Proposed ConnDOT Maintenance Facility

Willington, Connecticut

Eastern Connecticut Environmental Review Team Report

September 1996

Figure 10

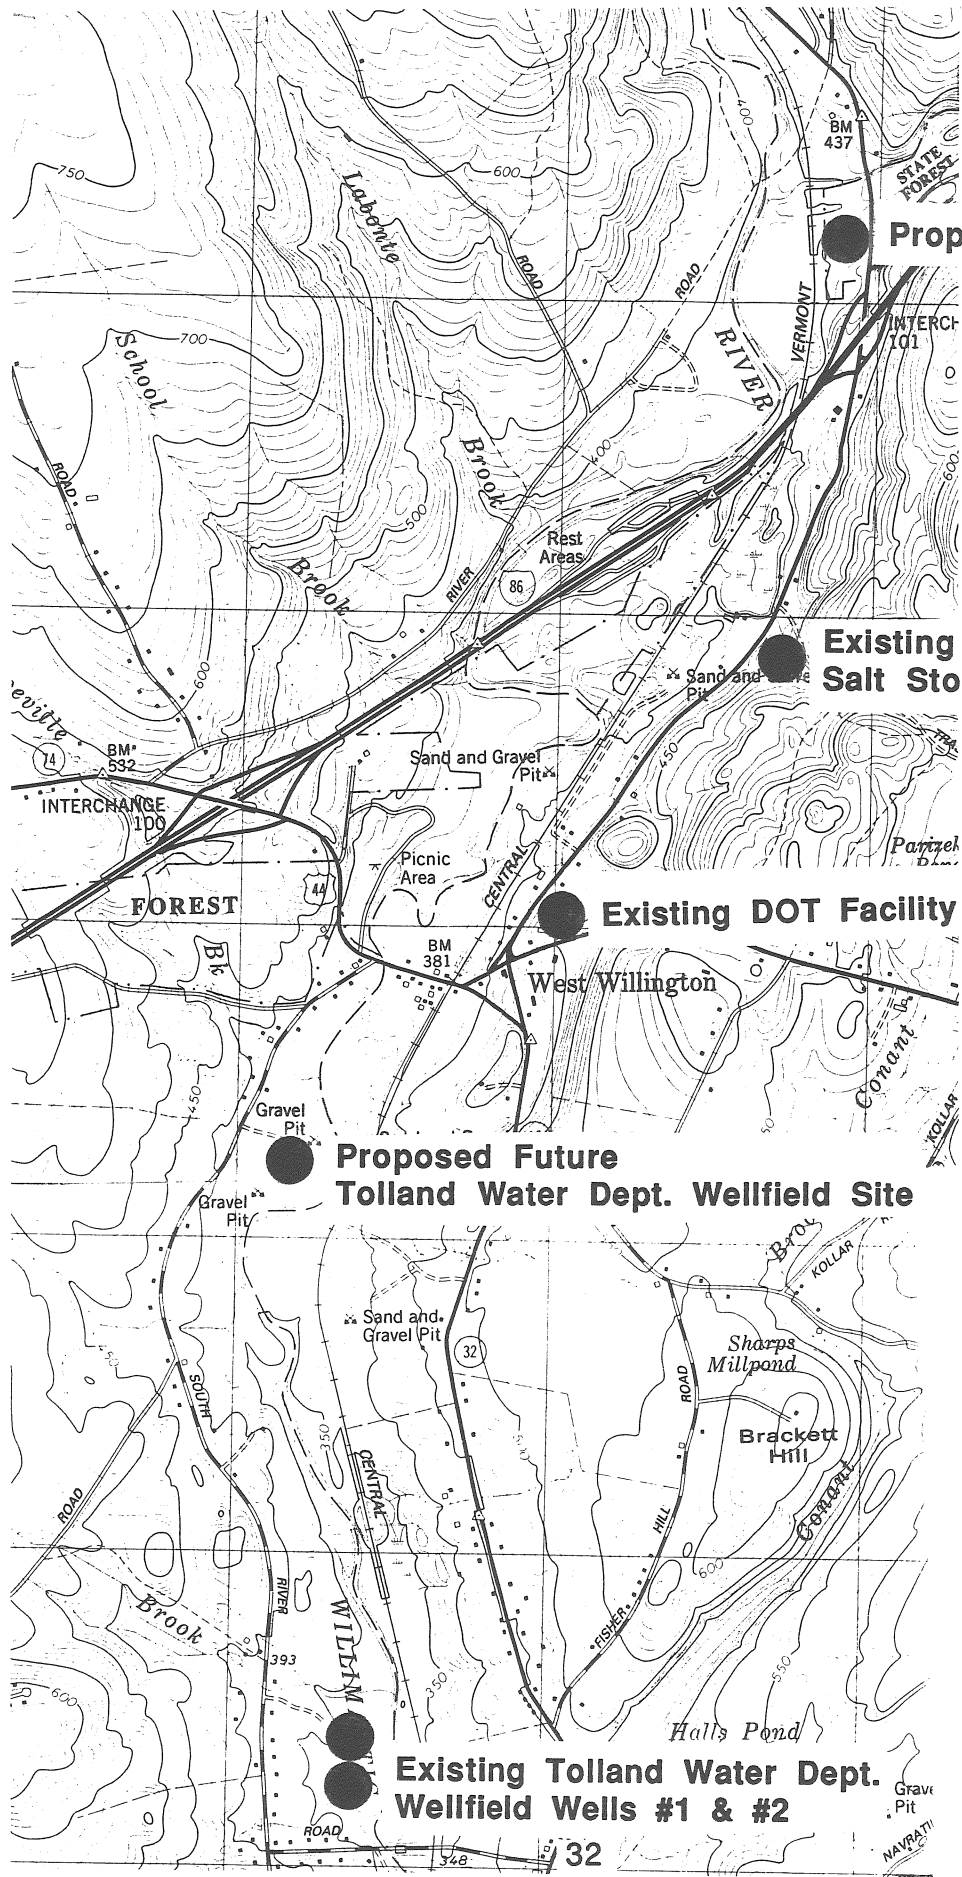
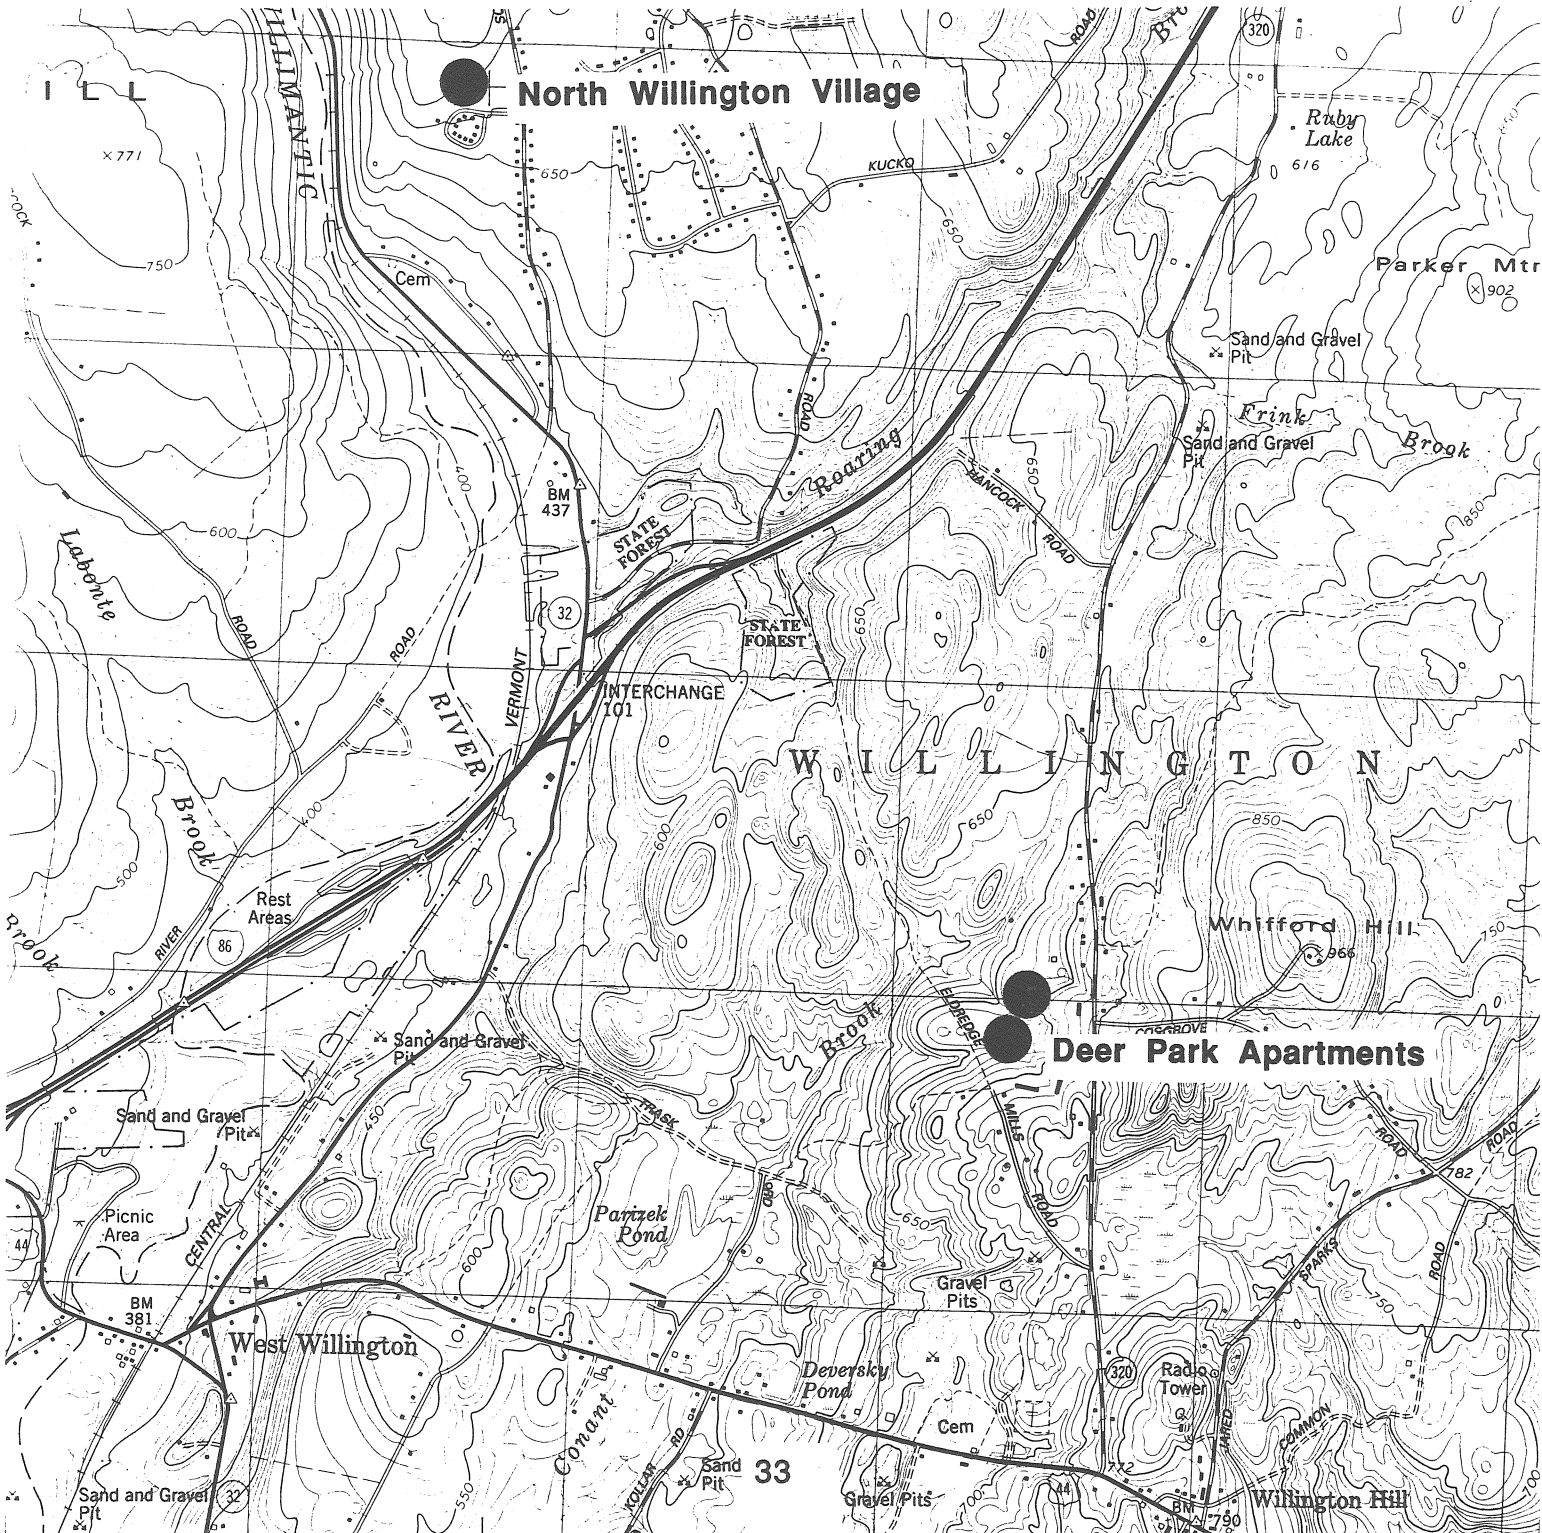
Based upon the above information, the proposed DOT facility is determined to have no impact to any existing public water supply sources as shown on Figures 10 and 11. The proposed DOT facility site is not located within the Level B aquifer recharge area of the Town of Tolland's existing public water supply well field. This no impact determination is based upon assumptions that all potential chemical spills can be contained by measures located on the proposed DOT site, and that appropriate best management practices for the handling of chemicals (including salt) are adhered to by DOT staff.

Figure 12

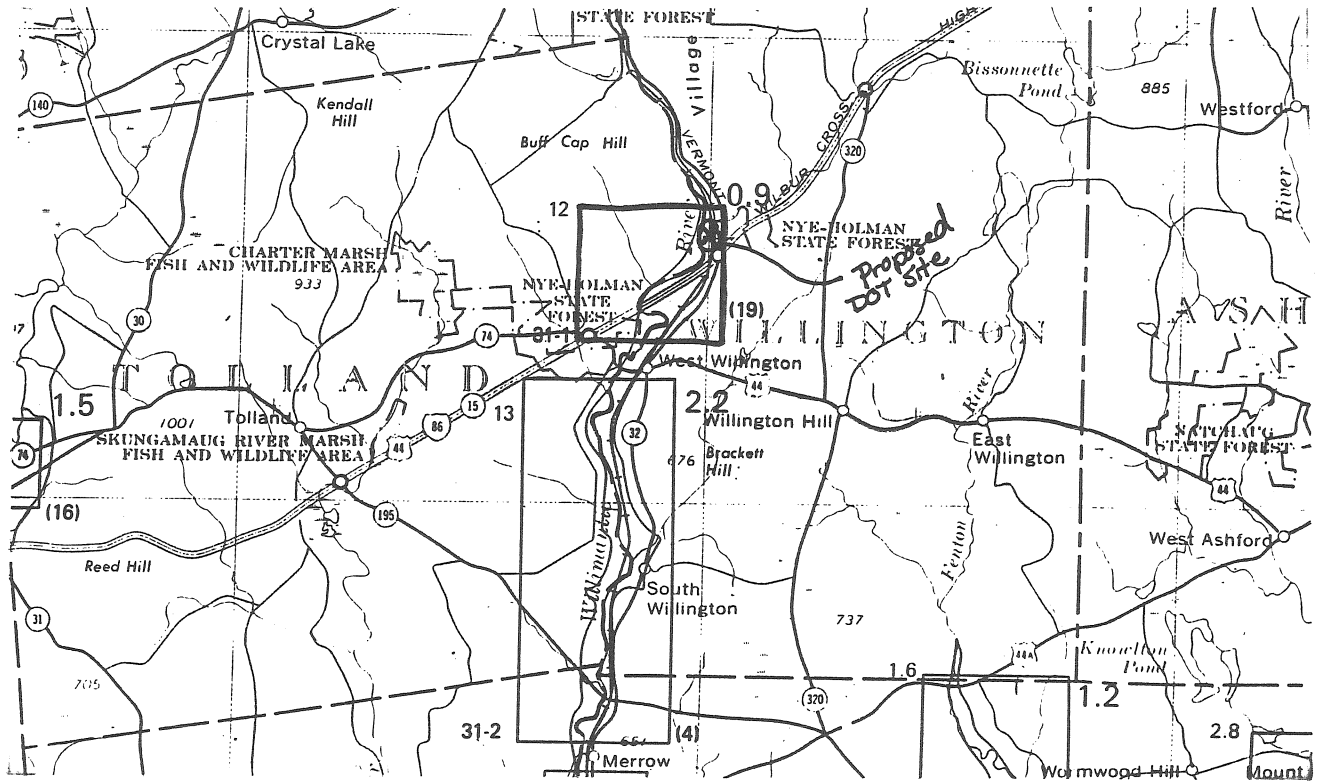
The Town of Willington has identified the proposed DOT facility site as a possible future potential public water supply well supply site for the Town of Willington. The Town has identified this area based upon data from the DEP Natural Resources Center 1986 study and mapping entitled *Ground-Water Yields for Selected Stratified*

Drift Areas in Connecticut (Figure 12). This area is shown to potentially yield 0.9 million gallons per day. Presently, the Town of Willington does not own or operate an existing public water supply system, nor have any formal water supply plan on file pursuant to Connecticut General Statute 25-32d with the Department of Public Health to serve future populations.
